STATE OF NORTH CAROLINA  
DEPARTMENT OF TRANSPORTATION

**Subject: Request for Modification to Section 404 Individual Permit and Section 401 Water Quality Certification** for the I-40/I-77 interchange improvements including I-40 from west of SR 2003 (Radio Road) to SR 2158 (Old Mocksville Road) and I-77 from south of SR 2321 (East Broad Street) to south of SR 2171 (Jane Sowers Road) in Iredell County. Division 12, TIP No. I-3819B. Debit \$570.00 from WBS 34192.3.2.

**References:** 1) Section 404 Individual Permit, Action ID No. SAW-2018-01504, issued January 21, 2020; 2) Section 401 Water Quality Certification No. WQC004203, NCDWR Project No. 20191006, issued November 19, 2019 and revised January 30, 2020.

The purpose of this letter is to request a modification to the United States Army Corps of Engineers (USACE) Section 404 Individual Permit and associated North Carolina Division of Water Resources (NCDWR) Section 401 Water Quality Certification for the above referenced project. This request letter includes a variance request for specific cross-pipes that will not be embedded, revisions to the drainage design, and modifications to permitted impacts.

PERMIT DRAWING  
SHEET 30 OF 67  
Rev. 11/02/2020

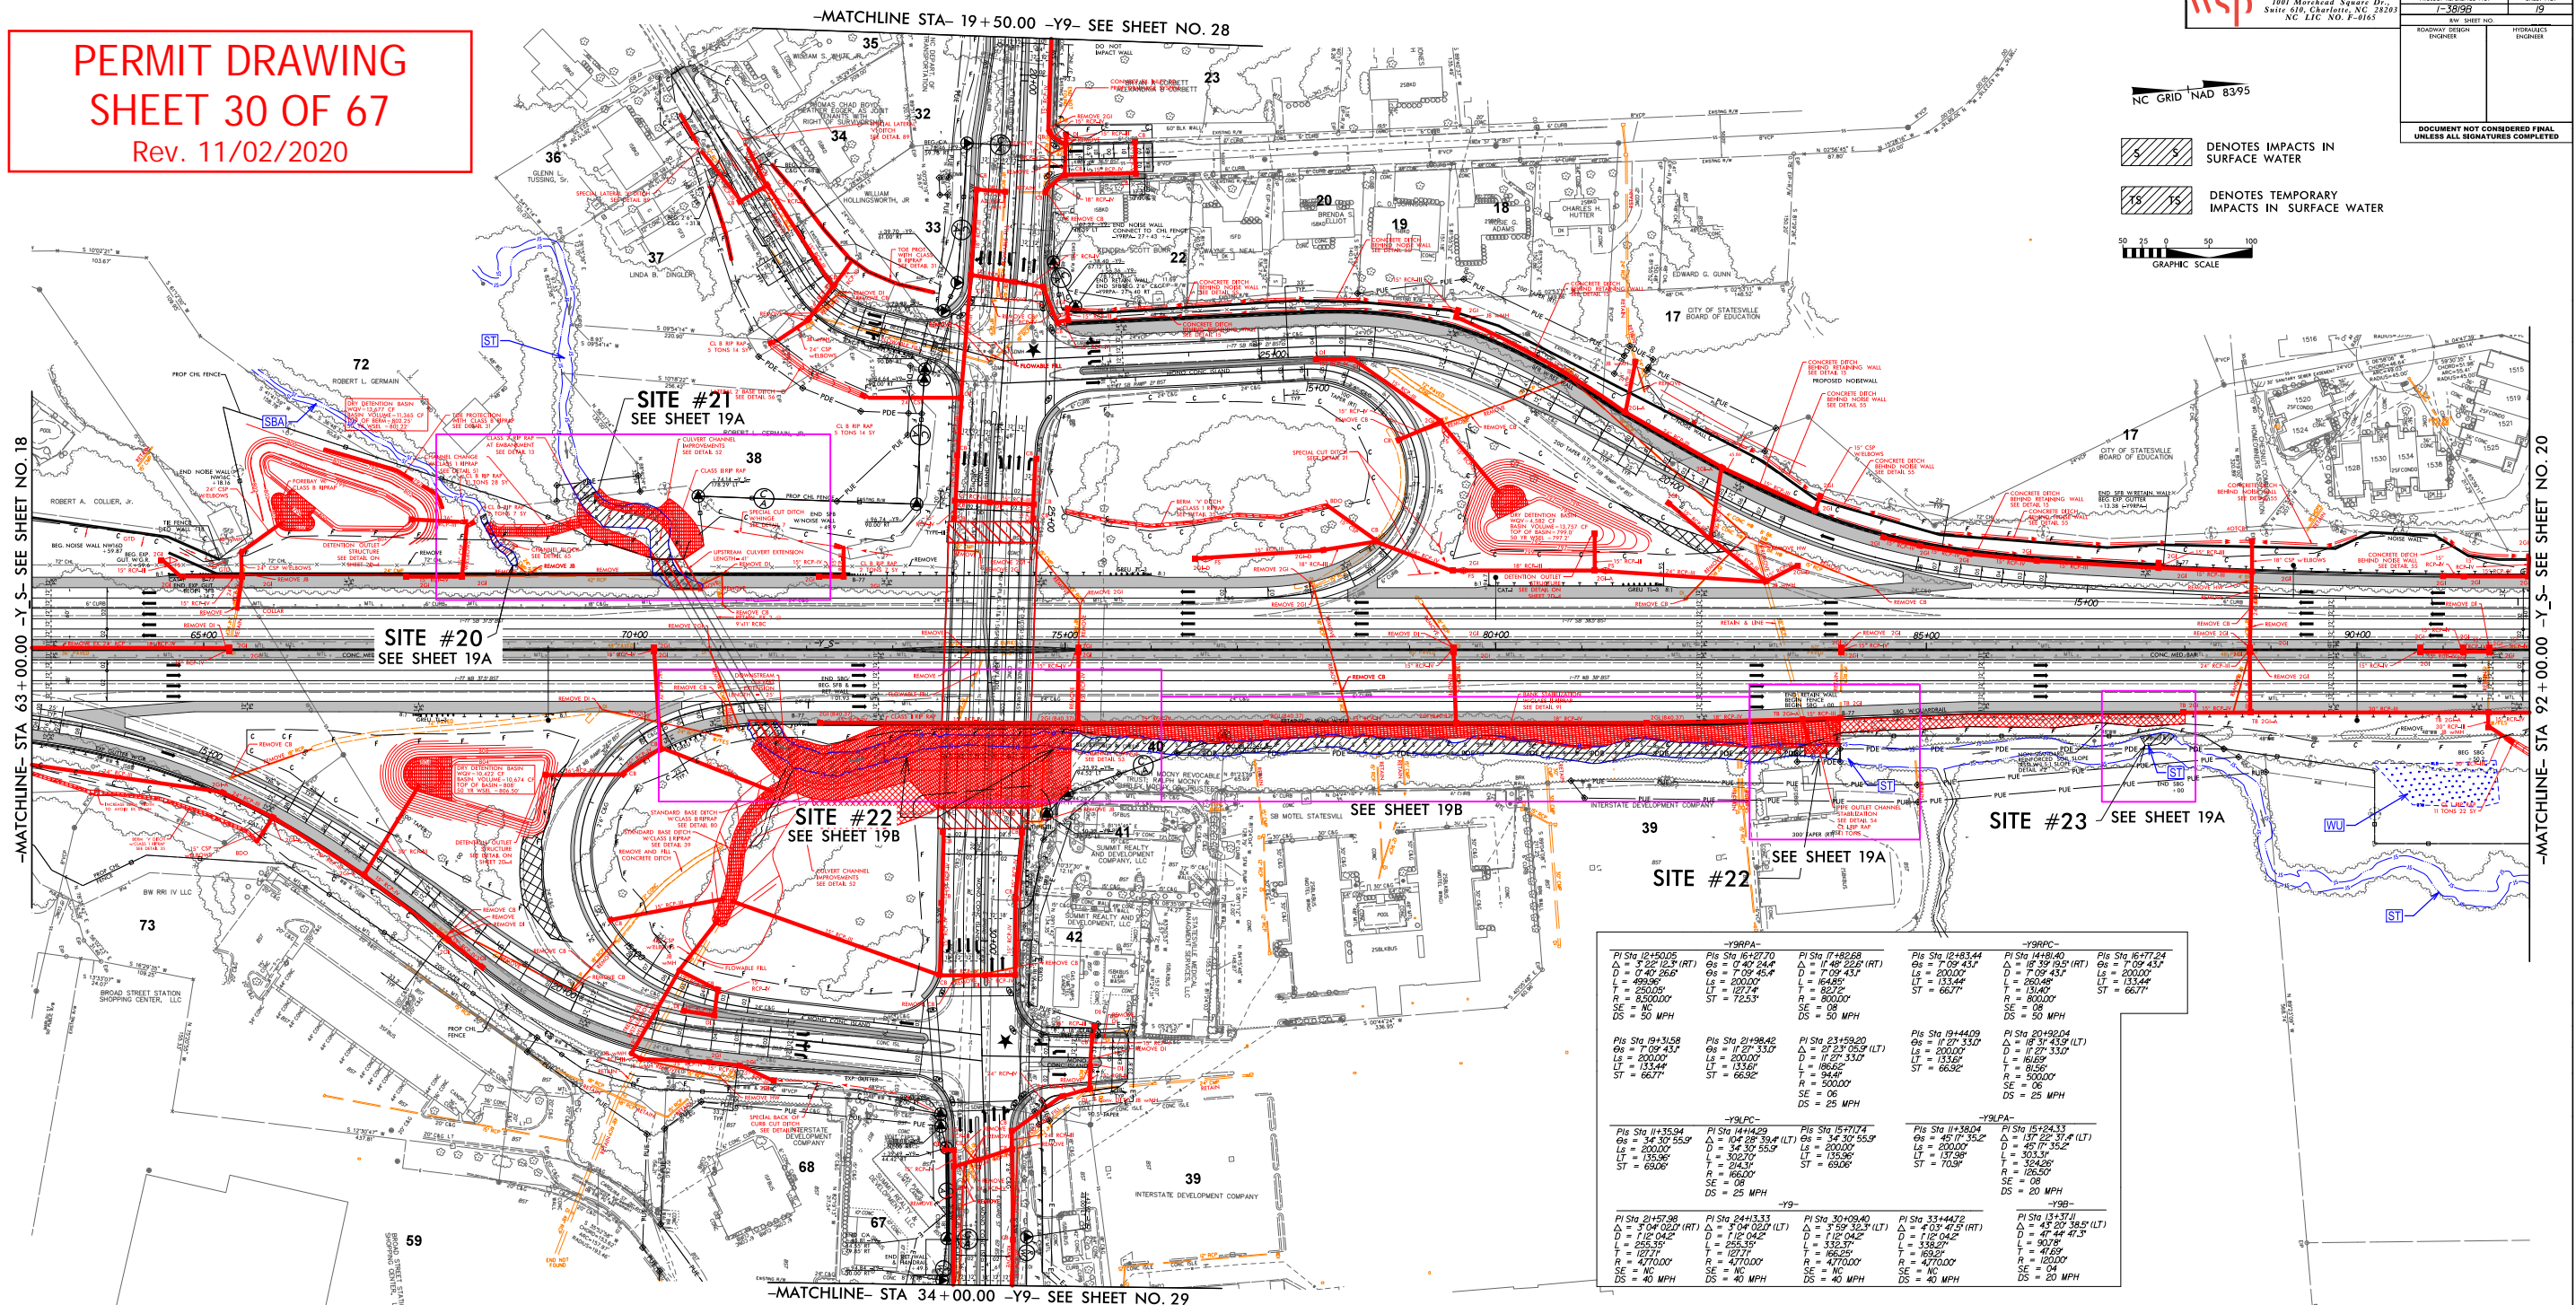
Site 21 (Permit Drawing Sheet 30) – There will be no changes to the design or proposed activities at this site from the approved permit; however, the jurisdictional stream boundaries of stream ST have been revised to more accurately follow the surveyed topographic contours. This revision will not result in any changes to the linear feet of permanent and temporary stream impacts. The total acreage of permanent stream impacts increased from 0.08 acre to 0.10 acre as a result of the revised jurisdictional stream boundary; temporary stream impacts will remain <0.01 acre.

Site 22 (Permit Drawing Sheet 30) – The jurisdictional stream boundaries of stream ST have been revised from those shown in the approved permit to more accurately follow the surveyed topographic contours. This revision will not result in any changes to the linear feet of permanent stream impacts for Site 22. Other revisions to impacts at Site 22 are as follows: in the approved permit, the permanent stream bed stabilization impacts were incorrectly calculated to extend 12 linear feet outside of the riprap in stream ST for the pipe outlet channel stabilization located at Station Number 83+85+00-Y. Also, in this location the permanent stream bank stabilization impacts should have been extended to the end of the riprap shown on the stream bank immediately adjacent to the channel, therefore the permit drawings have been revised to show an additional 16 linear feet of permanent stream bank stabilization impacts. Permanent stream bed impacts will decrease from 467 linear feet to 455 linear feet and bank stabilization impacts will increase from 873 linear feet to 901 linear feet. The previously approved 10 linear feet of temporary stream impacts were no longer needed and have been removed.

Site 23 (Permit Drawing Sheet 30) – There will be no changes to the design or proposed activities at this site from the approved permit; however, the jurisdictional stream boundaries of stream ST have been revised to more accurately follow the surveyed topographic contours. This revision will not result in any changes to the linear feet or acreage of temporary stream impacts at this location.

NOTE: PER COMMENTS RECEIVED FROM NCDOT ON 10/16/20, JS LINES HAVE BEEN MODIFIED ALONG SITES 21, 22, AND 23 TO FOLLOW THE SURVEYED TOPOGRAPHY. NO RIPRAP WILL BE PLACED IN THE STREAM BED ALONG AREAS OF BANK STABILIZATION.

PERMIT DRAWING  
SHEET 37 OF 67  
Rev. 11/02/2020

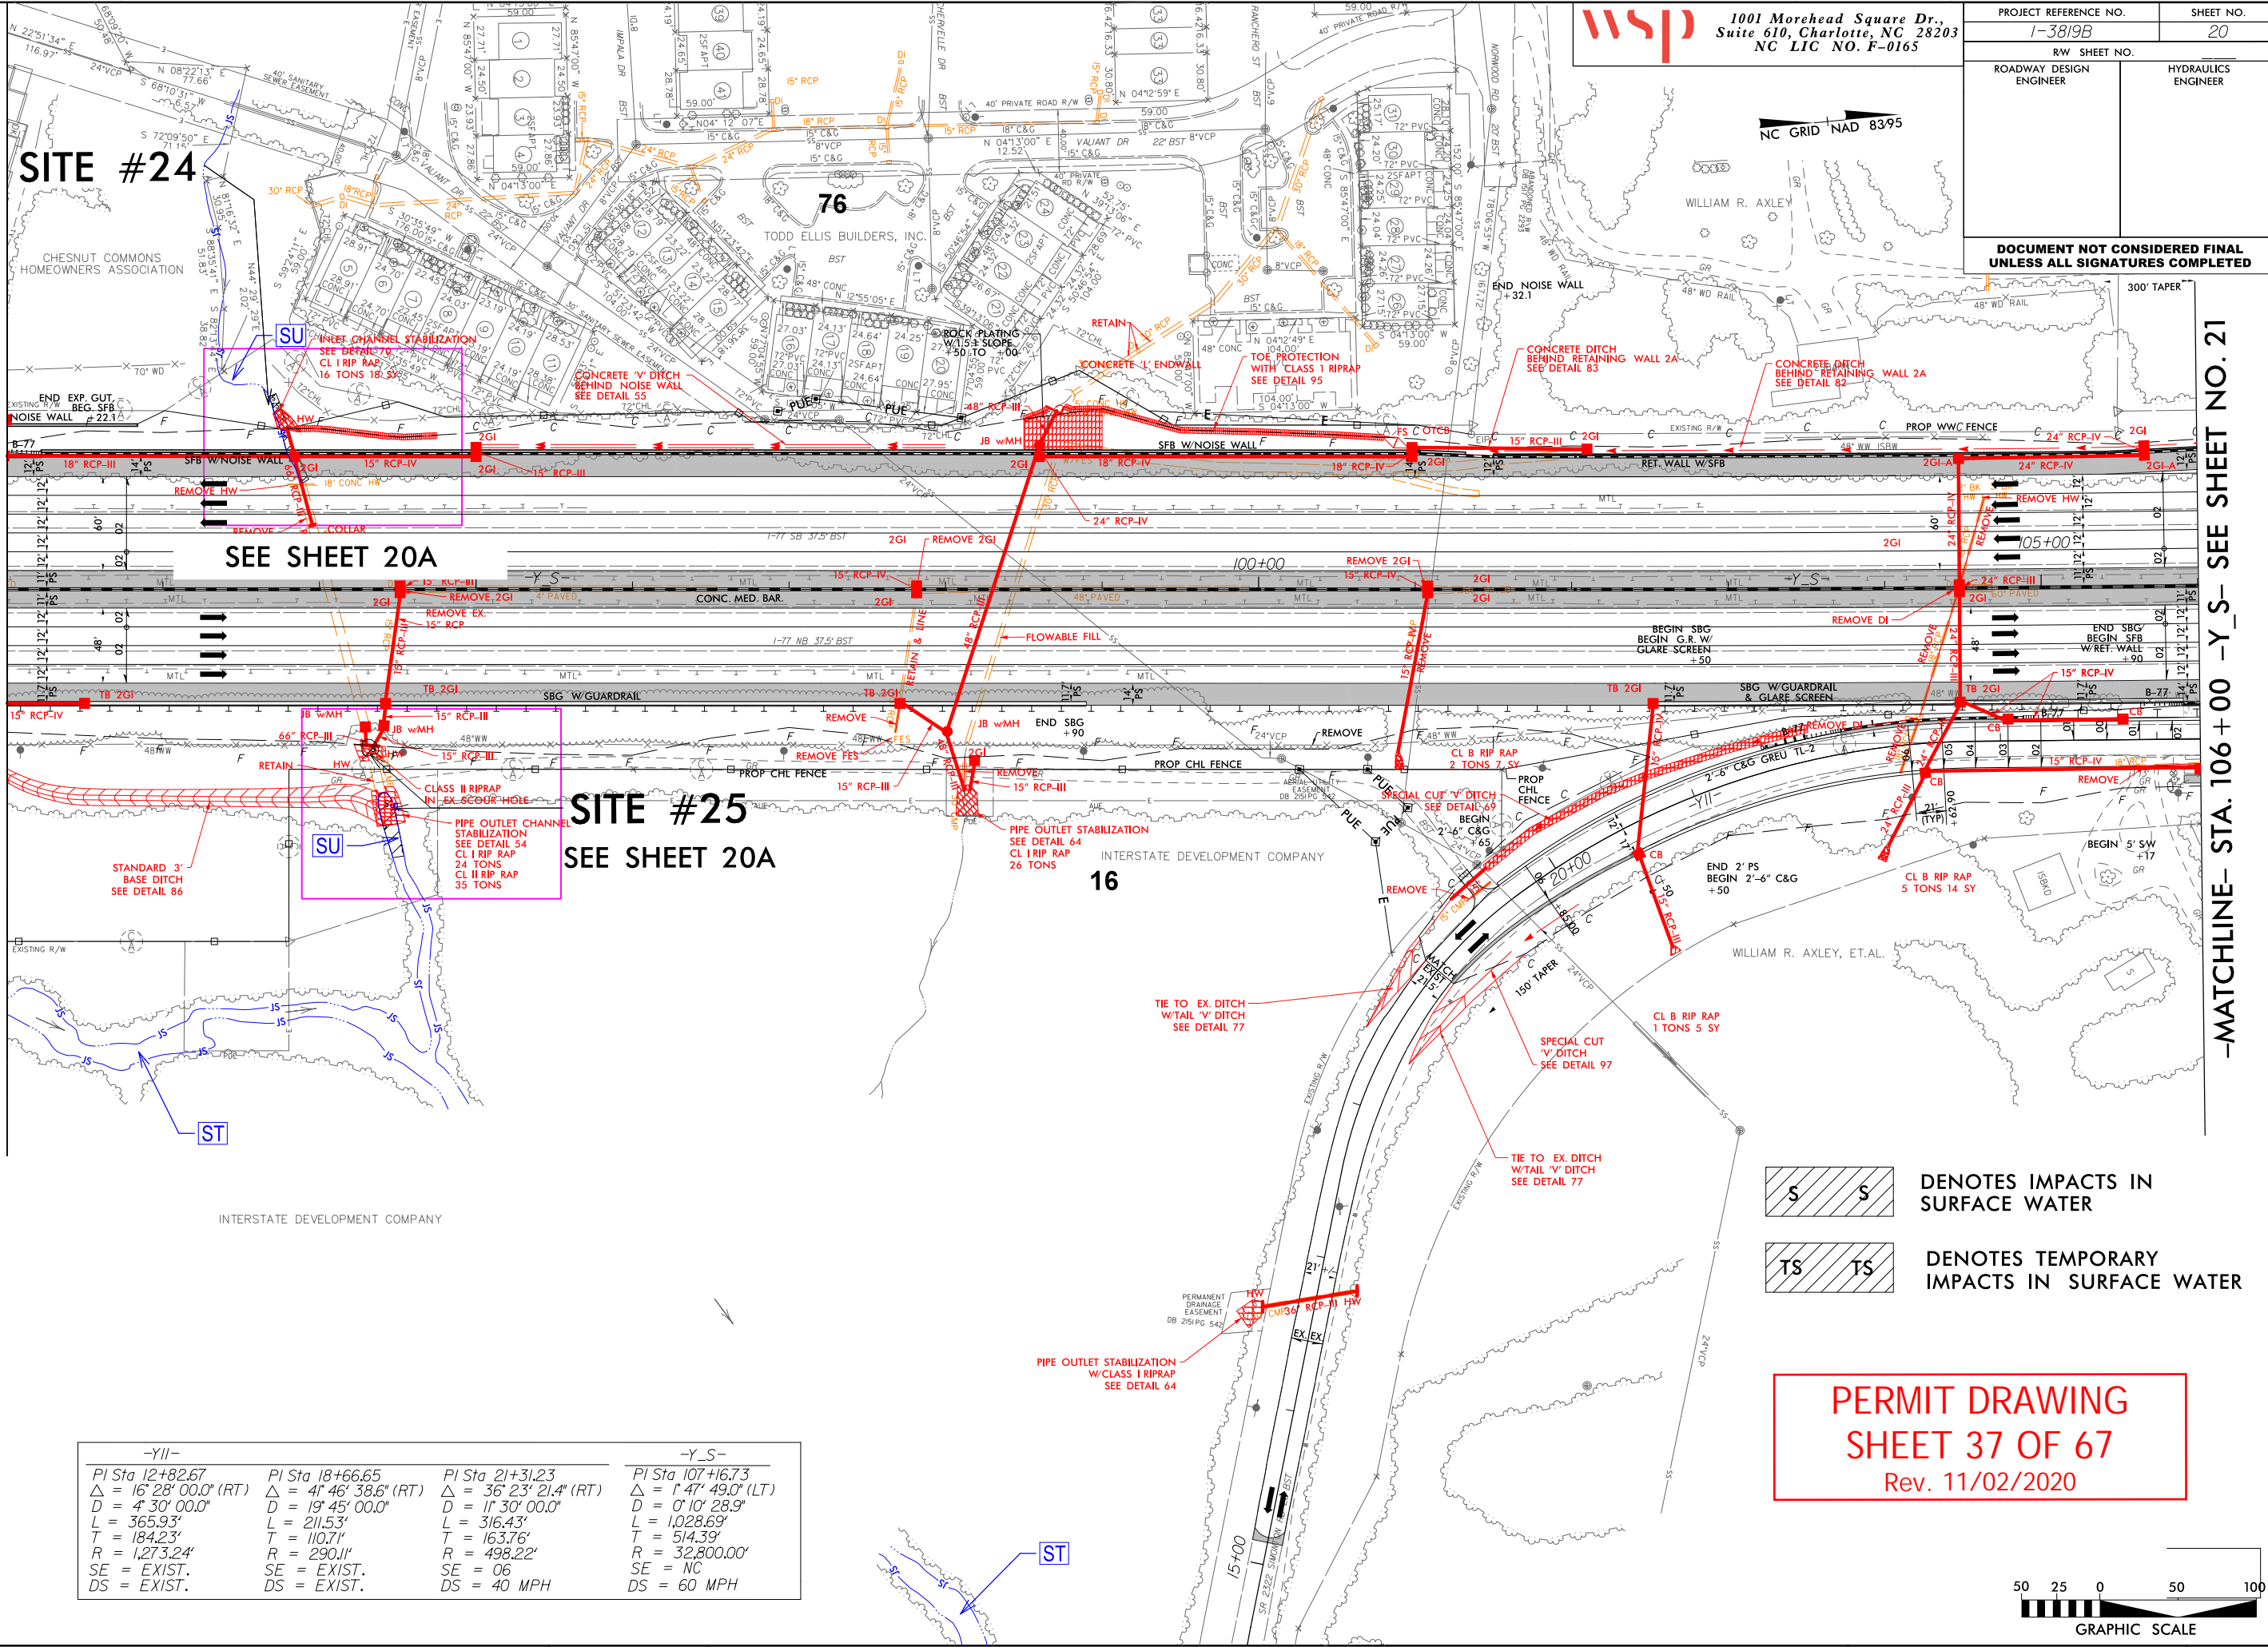
Site 25 (Permit Drawing Sheet 37) – In the approved permit, the drainage design included retaining an existing 15” RCP and connecting it to an existing 66” RCP, which carries stream SU, through a series of two junction boxes. The revised design includes replacing the 15” RCP and extending the pipe to discharge directly to stream SU instead of connecting to the existing 66” RCP. This revision will not result in any additional impacts.

Also, the detention basin shown in the original design impacting stream SU has been removed. The depth to the water table and proximity to the adjacent floodplain made the construction and operation of the detention basin infeasible. Permanent stream impacts decreased from 44 linear feet to 31 linear feet, which is a 13 linear foot decrease in impacts. Temporary stream impacts will decrease from 32 linear feet to 21 linear feet, which is an 11 linear foot decrease in impacts.

PERMIT DRAWING  
SHEET 46 OF 67  
Rev. 11/02/2020

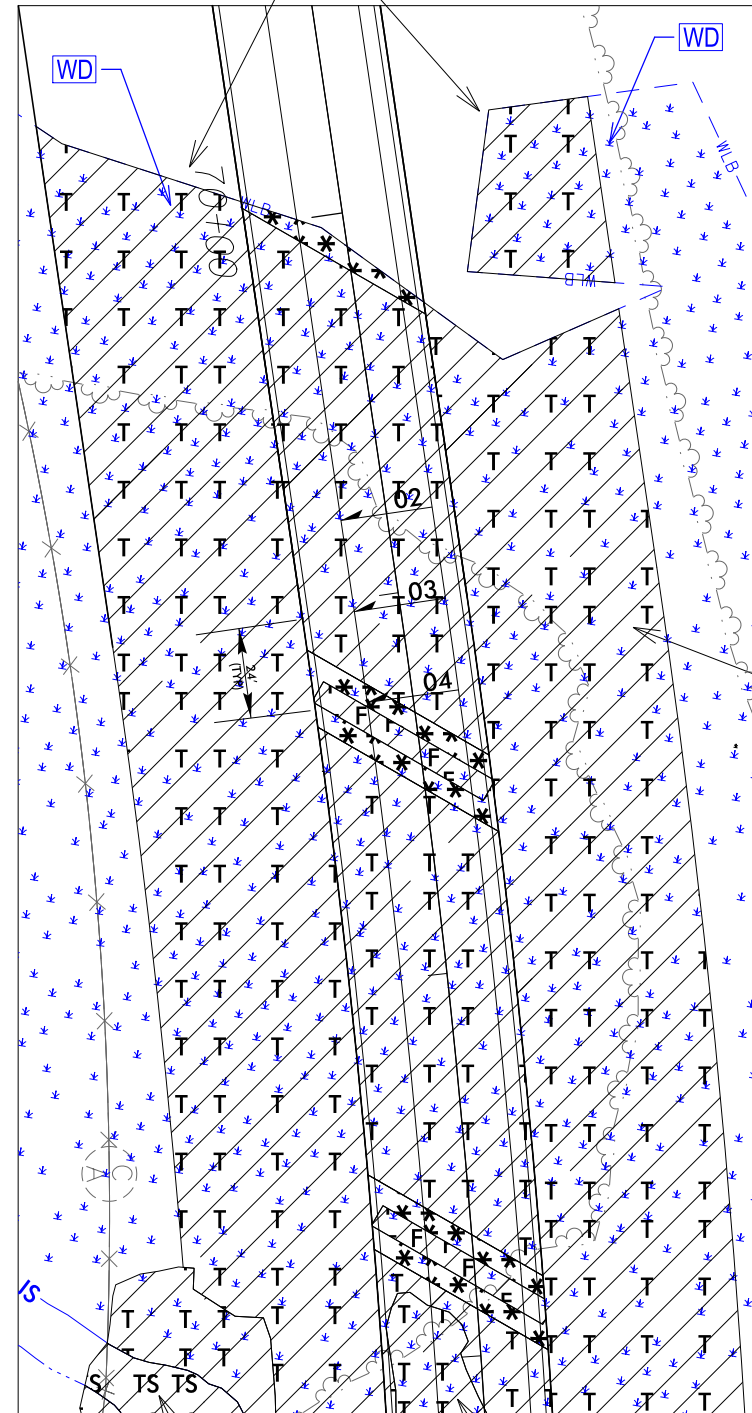
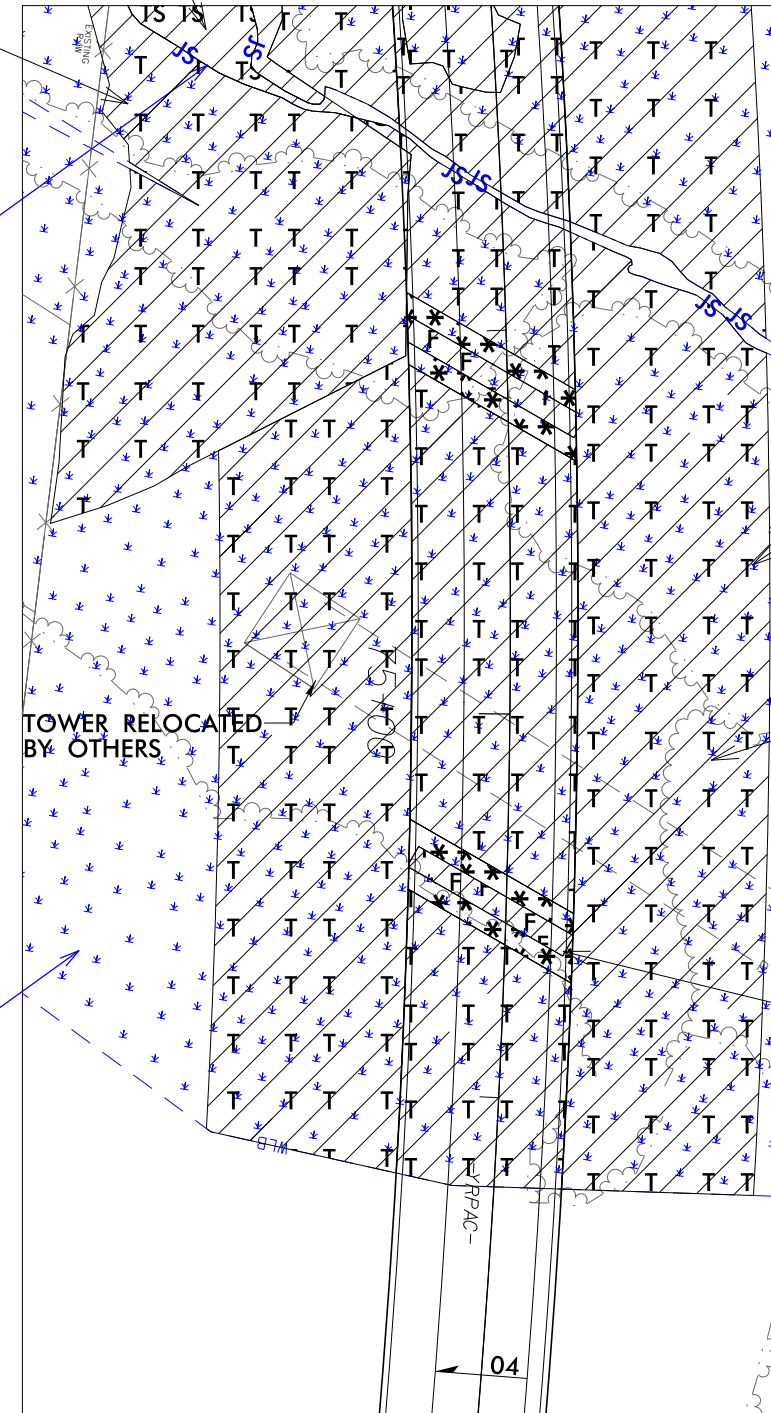
Site 5 (Permit Drawing Sheet 46) – This site has been updated to incorporate unauthorized impacts to wetland WD and stream SJ that occurred inadvertently during construction. The 40 linear feet of permitted temporary stream impacts to stream SJ on the east side of the bridge alignment have been eliminated because the temporary pipe was not needed. However, there were 77 linear feet of unauthorized temporary stream impacts to stream SJ. Therefore, temporary stream impacts increased from 40 linear feet to 77 linear feet, which is 37 linear feet of additional temporary stream impacts. There are no permanent stream impacts proposed for this site.

Permitted hand clearing impacts have been converted to temporary wetland fill impacts in areas where mats and barges are being used during construction. In addition, 0.10 acre of temporary wetland fill outside of previously permitted hand clearing impacts were added to account for the unauthorized temporary impacts within wetland WD. Impacts for hand clearing in wetlands decreased from 1.94 acres to 0 acre, and 2.04 acres of temporary wetland fill impacts are now included. There will be no additional permanent impacts at this location.

On-site restoration was performed to mitigate for the unauthorized impacts that included 0.23 acre of temporary impacts to wetland WD (0.10 acre were outside of previously permitted hand clearing impacts) and 77 linear feet of temporary impacts to stream SJ. To restore the areas, the stream banks and a section of wetland WD were regraded and stabilized with erosion control matting. Native grass seeding and mulching were used for all temporarily impacted wetland areas and stream banks. On June 3, 2020, Lane Construction met on-site with Donna Hood with NCDWR and Matthew Evans with NCDOT to inspect the restoration areas and review the progress of restoration activities. A response to the Notice of Deficiency and the wetland restoration plan for the unauthorized impacts were submitted on June 25, 2020 to NCDWR and was accepted by NCDWR and USACE on June 30, 2020 as indicated through coordination with Donna Hood.
